Plan & Architectural Review Meeting

Monday, July 13, 2026 - 6:00 PM

To: City of Whitewater Plan and Architectural Review Commission

RE: Conditional Use Permit and Site Plan Review

Proposed Site Plan:

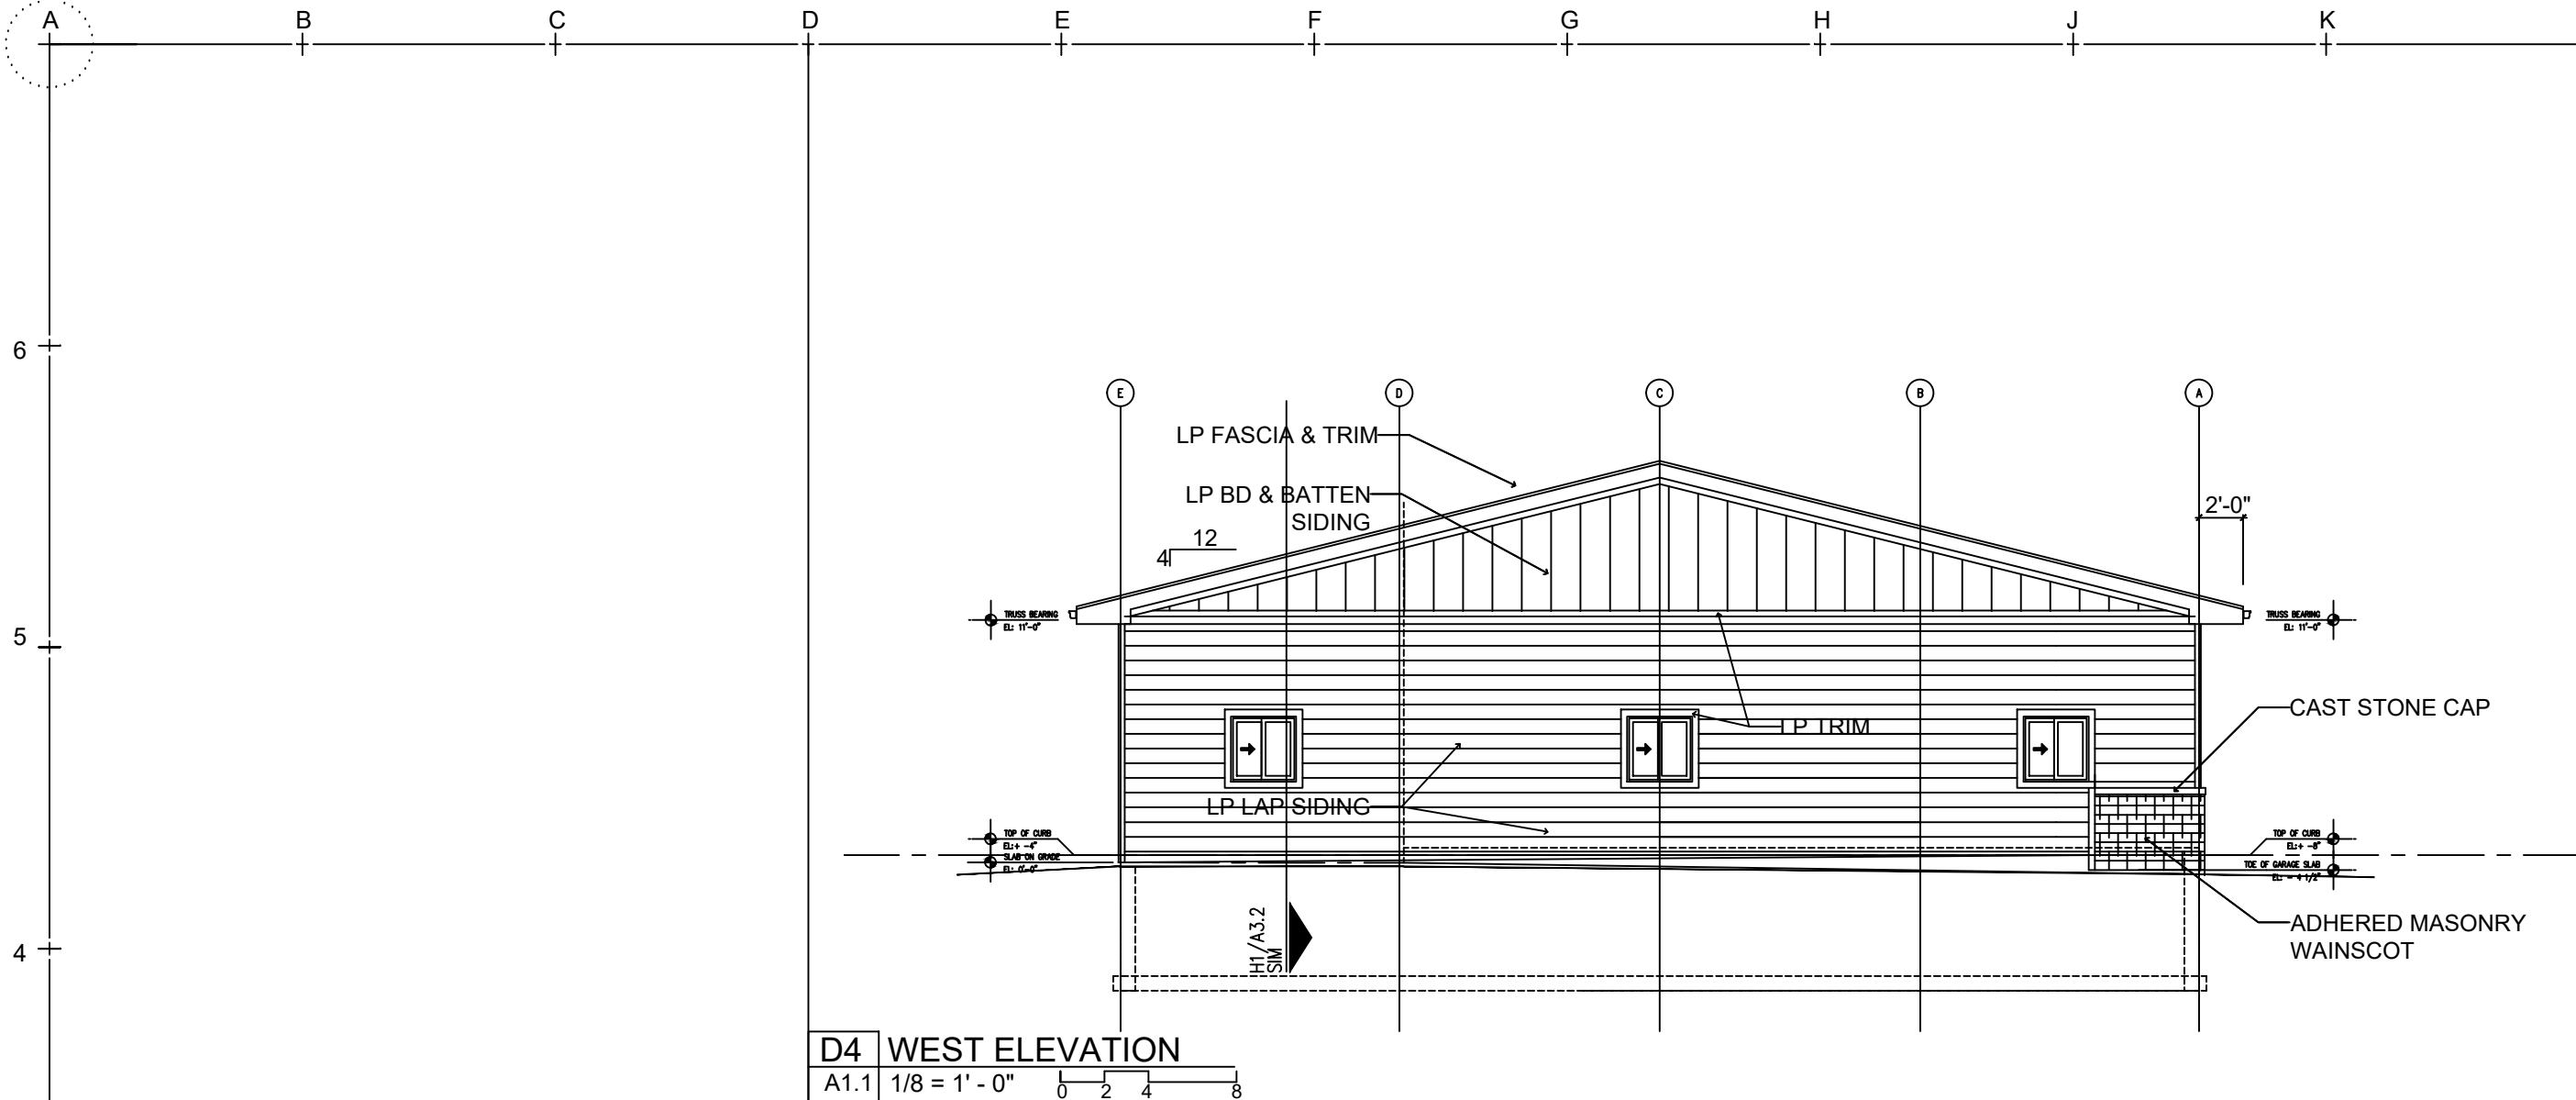
This request presents a policy question that extends beyond the individual property. Approval of a 2,263-square-foot residential accessory building may establish a precedent for future requests involving similarly sized residential accessory structures within the City. While each Conditional Use Permit must be evaluated on its own merits, previous approvals are frequently referenced by future applicants when seeking comparable relief.

The Commission should therefore consider whether approval of this request reflects the long-term policy direction it wishes to establish regarding the maximum scale of residential accessory buildings.

The Commission should consider whether the proposed structure remains subordinate and incidental to the principal residential use. Although accessory buildings may exceed the footprint of some homes, their size should generally remain clearly secondary to the principal use of the property and compatible with surrounding development. The proposed structure appears to be larger than the existing home on the parcel.

Staff finds that the proposal exceeds the size of accessory structures commonly found on residential properties within the City and presents a policy question regarding the appropriate scale of residential accessory buildings permitted through the Conditional Use Permit process. While the ordinance authorizes the Plan Commission to consider structures exceeding 800 square feet, approval of a building of this size may influence future land use expectations and should therefore be evaluated not only on the merits of the subject property but also in the context of the City's broader zoning policies. The Plan Commission should determine whether the proposed accessory structure is compatible with the surrounding area, consistent with the intent of the zoning ordinance, and appropriate as a matter of long-term land use policy.

Proposed Site Plan

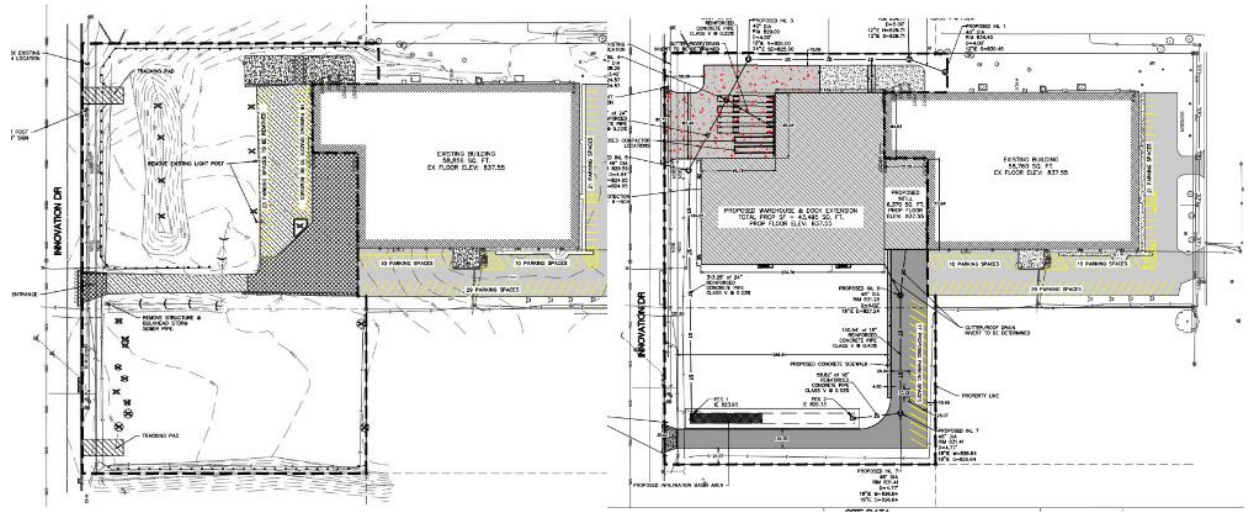
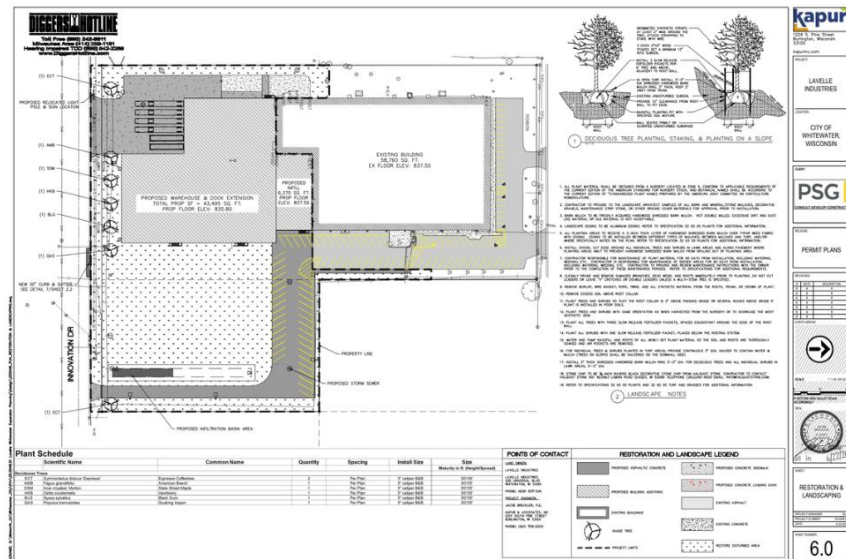
The applicant, Lavelle Industries, is requesting a site plan review for the expansion of the existing parking lot in conjunction with the previously approved ongoing expansion of the facility. The proposed lot expansion is intended to accommodate operational needs of the facility, adding 37 additional parking stalls with no other changes in the site plan.

- 1) Staff recommends that the Plan Commission **APPROVE** the Amended Site Plan with the following conditions:
 - a. All lighting shall comply with the City of Whitewater Ordinances.
 - b. All new or additional signage on site shall be approved by the zoning department, and a separate application will be required.
 - c. All zoning and building permits for construction be properly obtained.
